LIGHTED CUP HOLDERS
W/ USB (RAF CHBR1ULSL01) Ⓢ

CUT PATTERN	
BACK FRAME NO.	
BASE FRAME NO.	
WOOD PATTERN

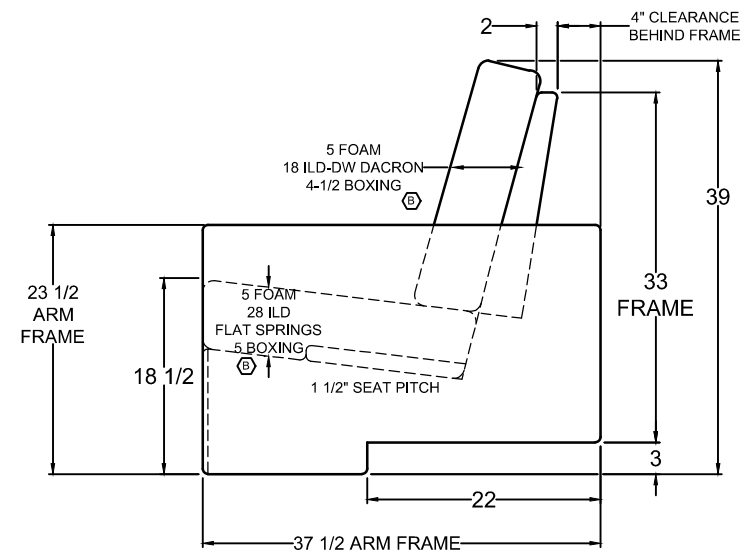
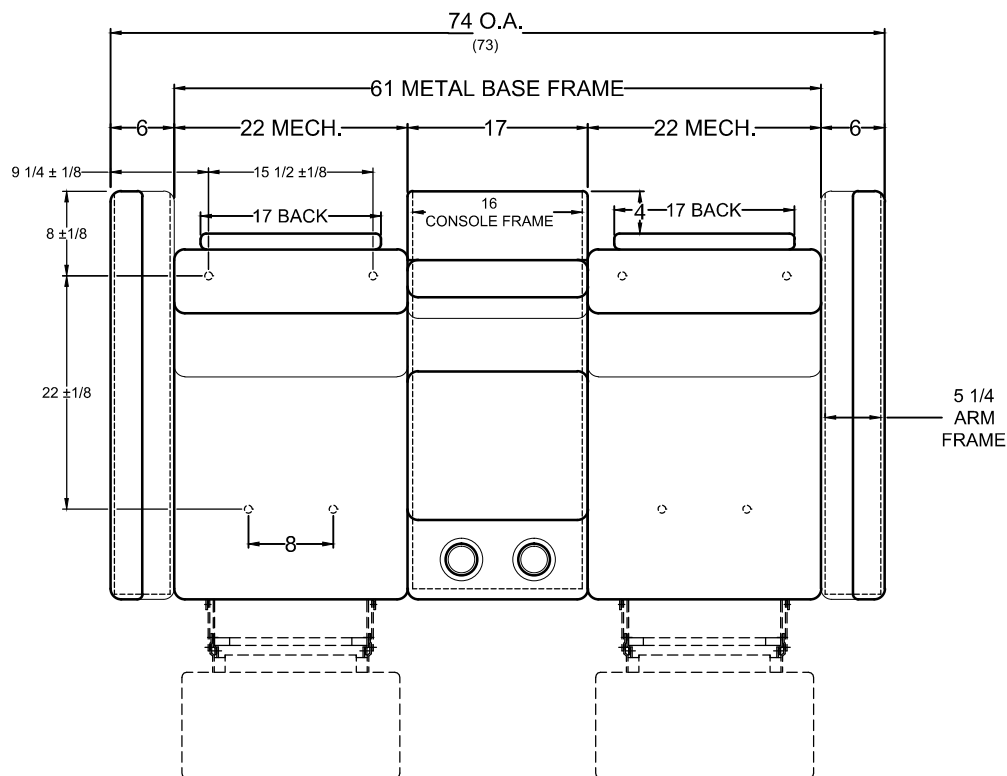
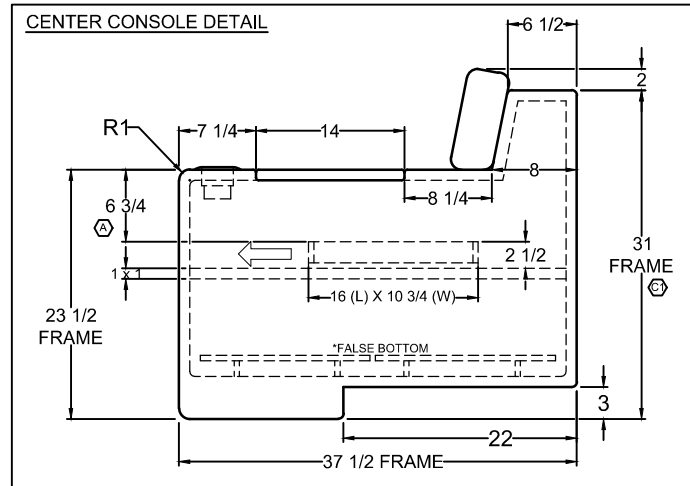
JA	C	PER RL, [1] CHANGE CONSOLE BACK FRAME HEIGHT TO 31"; WAS 28". [2] ADD CUP HOLDER PART NUMBER TO DRAWING. [3] ADD S/O TO ISO DRAWING.	07.11.24
JA	B	PER LP, ADD 4-1/2" BOXING TO BACK PILLOW AND 5" BOXING TO SEAT CUSHION.	05.29.24
JA	A	PER RL, CORRECT CONSOLE SHELF HEIGHT TO 6-3/4"; WAS 4-3/4".	02.21.24
